REGIONAL REVIEW NOTIFICATION

DATE: August 10, 2021 ARC REVIEW CODE: R2108091

Name of Proposal: Waldon Park DRI #3257

WALDON PARK DRI #3257 Clayton County ARC Natural Resources Group Review Comments

3.0

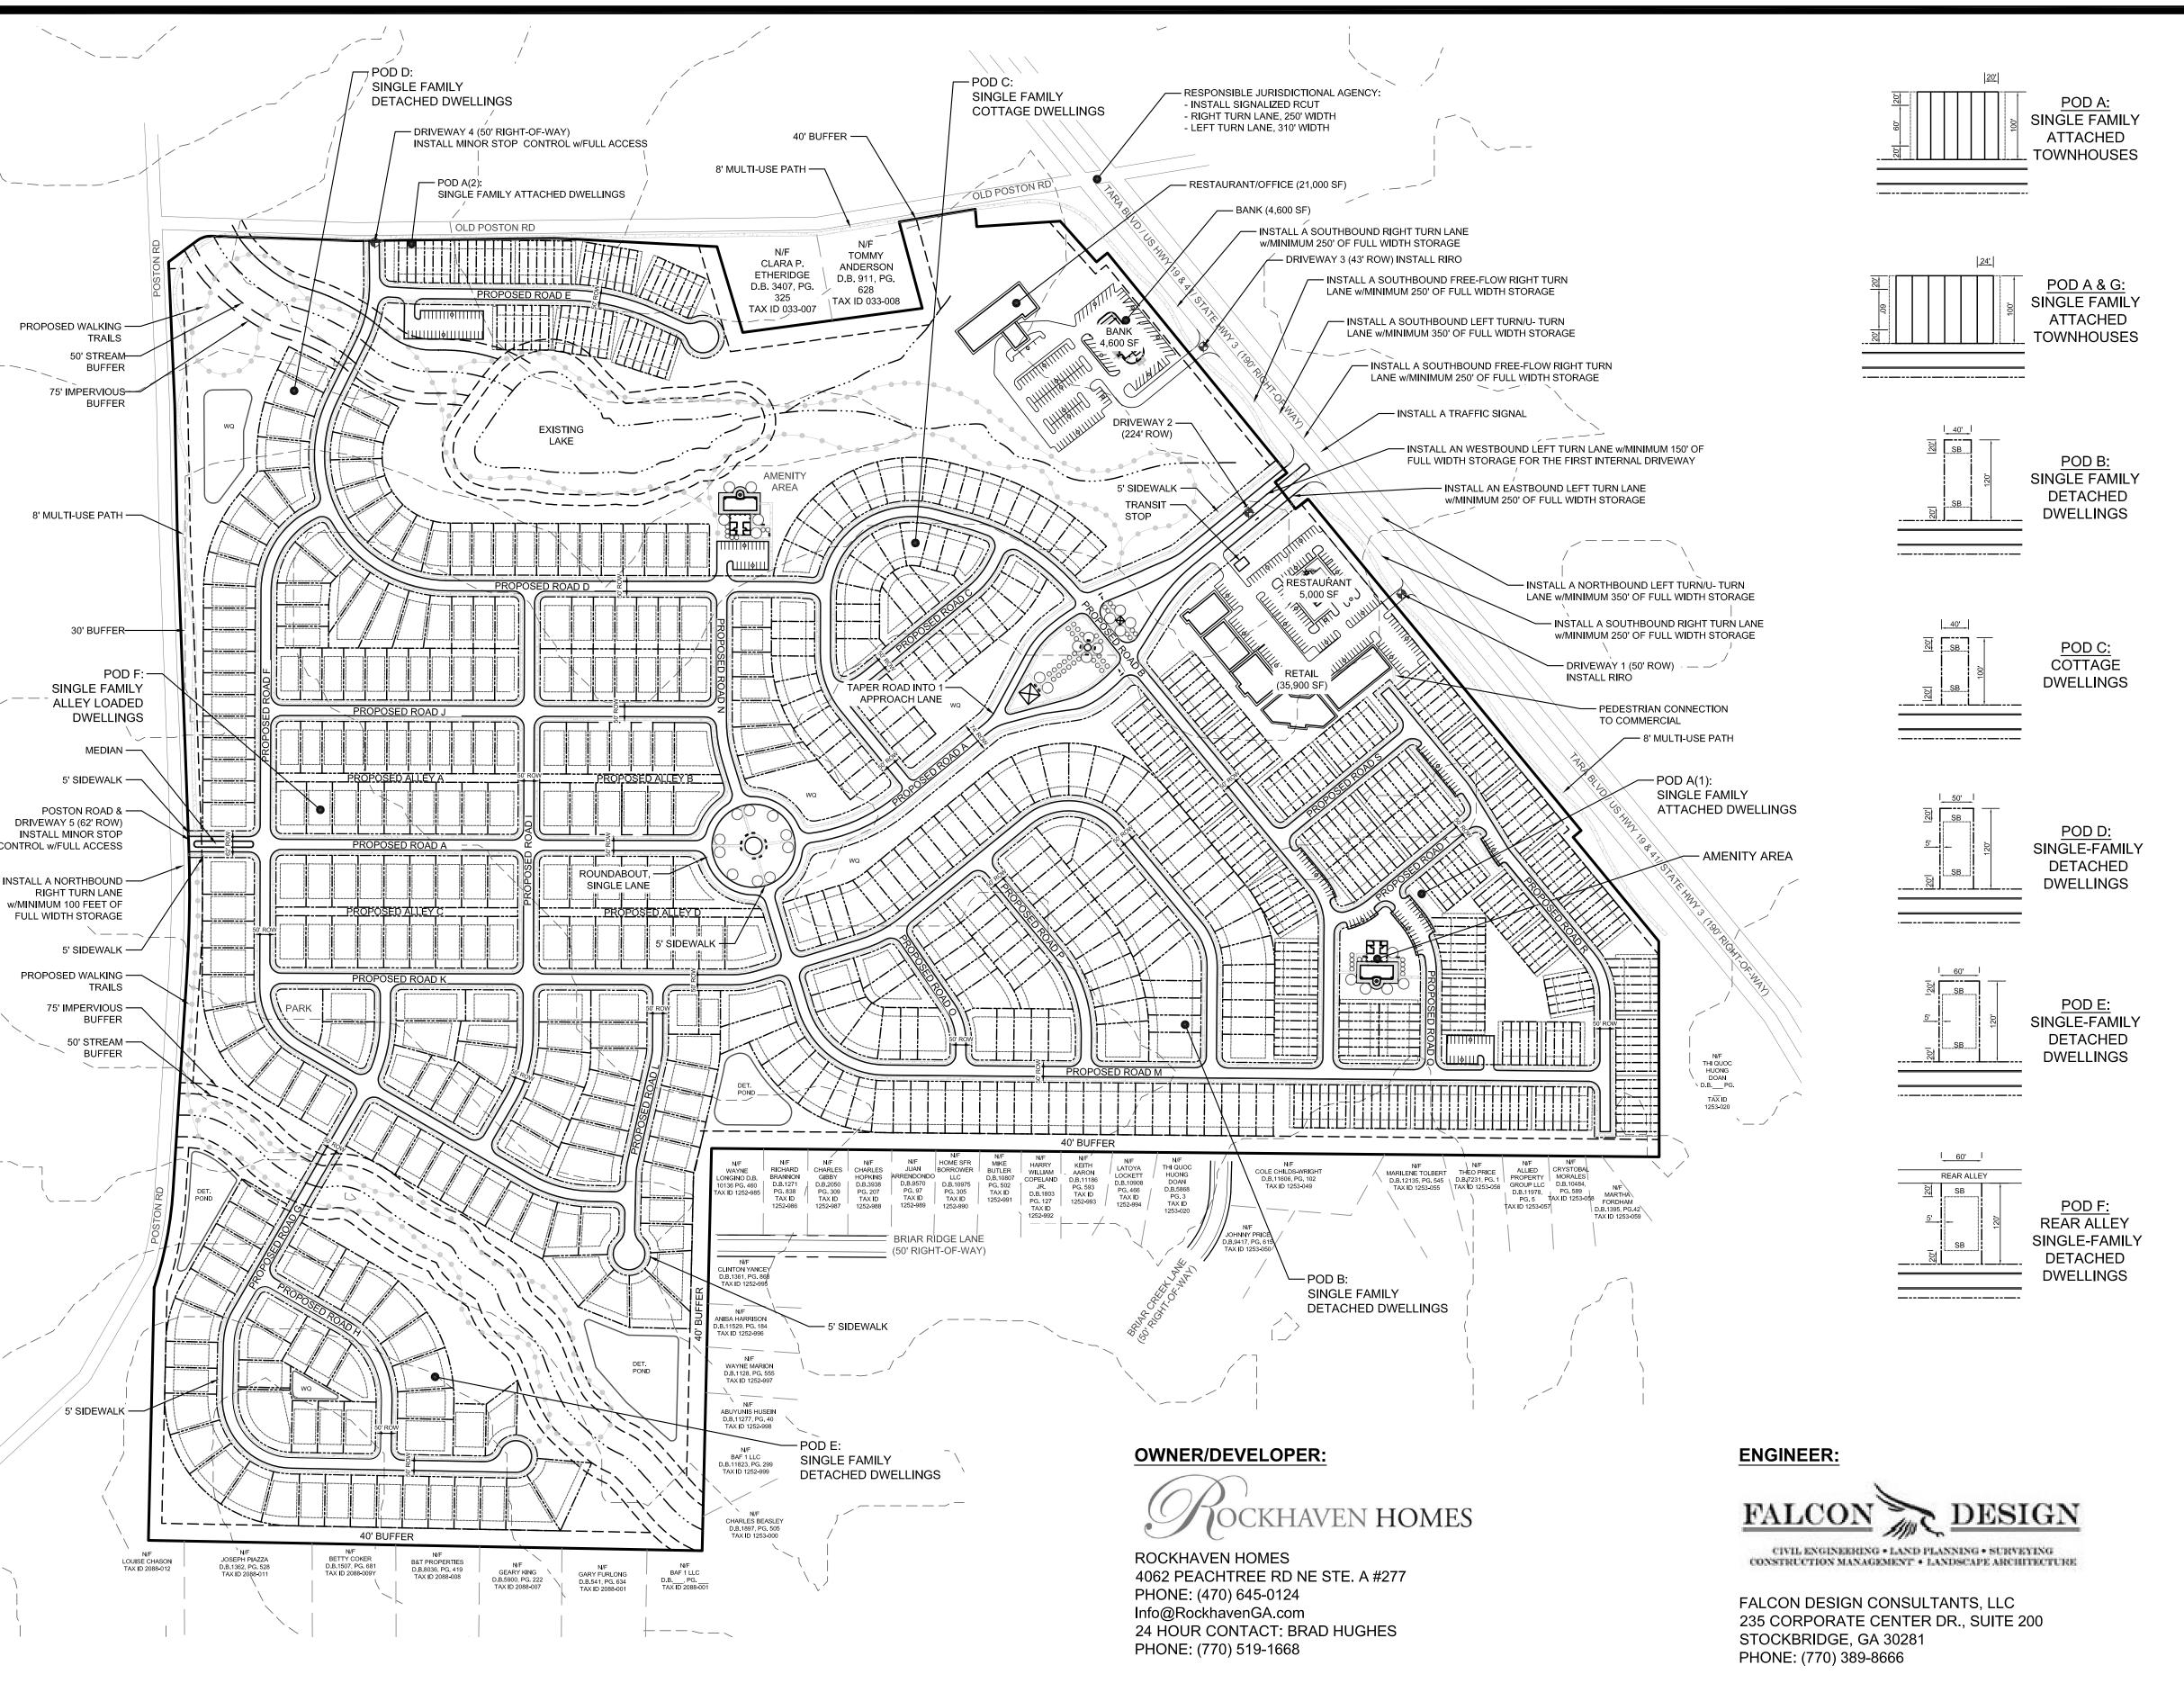
Additional comments from ARC's Natural Resources Group are attached. They indicate that the DRI site plan shows a lake and stream in the northern part of the property and a stream in the southwest part of the property. The 50-foot undisturbed buffer and additional 25-foot impervious surface setback (total of 75 feet) required under the Clayton County Stream Buffer Ordinance are shown along both streams, but the applicable 25-foot State Erosion and Sedimentation Act buffer is not clearly identified for either stream. The only development activities shown in the stream buffers are internal street and sidewalk crossings (Road D and Road G), but this activity may require County and/or State variances.

The USGS coverage for the project area shows an existing pond but no streams on the project property. Both the pond and a stream running through it are shown on the submitted site plan. In addition, a second stream crosses the southwest portion of the project property. The 50-foot undisturbed buffer and 25-foot impervious surface setback required under Clayton County Stream Buffer Ordinance are shown along both streams. The Georgia 25-foot State Erosion and Sedimentation Act buffer also applies to both streams but is not shown on either stream on the plans. The only development activity shown within the stream buffers on both streams are driveway and sidewalk crossings, which may require variances. Any unmapped streams may also be subject to the County Buffer Ordinance and all unmapped waters of the state may be subject to the 25-foot State Erosion and Sedimentation Act Buffer.
